**TECHNICAL BULLETIN**  
**Bell Helicopter** **TEXTRON**

No. 214ST-99-162

**MODEL AFFECTED:** 214ST

**SUBJECT:** INTRODUCTION OF P/N 214-030-626-103 CLEVIS AND P/N 214-031-601-129 RESTRAINT ASSEMBLY; AND, MODIFICATION OF P/N 214-030-626-101 CLEVIS

**FIGURE 1**  
REWORK OF P/N 214-030-626-101 CLEVIS

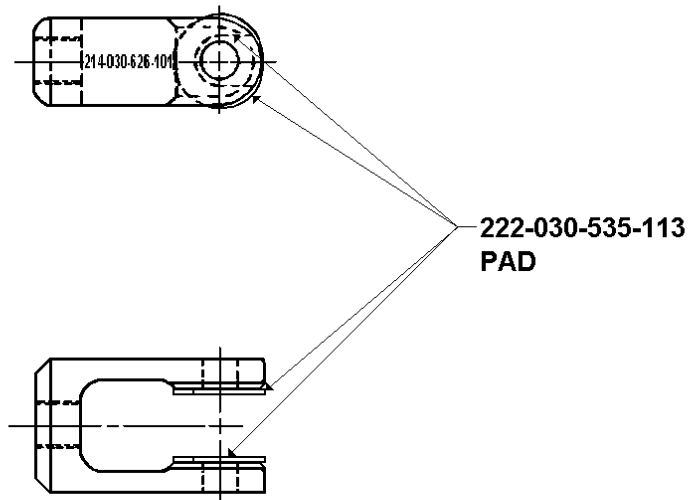
BHT has received reports of damage sustained by the P/N 214-031-608 Stop Assembly due to rotational contact of the P/N 214-030-626-101 Clevis about the stop assembly bearing. As a result, P/N 214-031-601-129 Restraint Assembly has been developed which incorporates a new P/N 214-030-626-103 Clevis Assembly. The P/N 214-030-626-103 Clevis Assembly is similar to the -101 Clevis except for the addition of rubber washers bonded to the inside surface of the clevis ears. These washers protect both the clevis and the stop from damage due to rotation about the stop assembly bearing.

Existing P/N 214-031-601-107 Restraint Assemblies and P/N 214-030-626-101 Clevises may be reworked to the new configuration.

3. Trim away one side of the P/N 222-030-535-113 Pads as noted in Figure 1.
4. Refer to BHT-ALL-SPM, Chapter 7, and prepare the faying surfaces between the P/N 222-030-535-113 Pads and the P/N 214-030-626-101 Clevis ears for bonding.

5. Bond one P/N 222-030-535-113 Pad to the inner surface of each ear on the P/N 214-030-626-101 Clevis per BHT-ALL-SRM, Chapter 7. Ensure the pads are located such that the trimmed portion faces away from the restraint. Allow to cure.

6. Reinstall Clevis Assembly on the P/N 214-031-612 Restraint per 214ST Maintenance Manual, Chapter 63.
7. At a convenient location on the P/N 214-031-612 Restraint body, clean the surface to remove oils and dirt and reidentify the assembly as P/N 214-031-601-129 with black indelible metal marking ink.
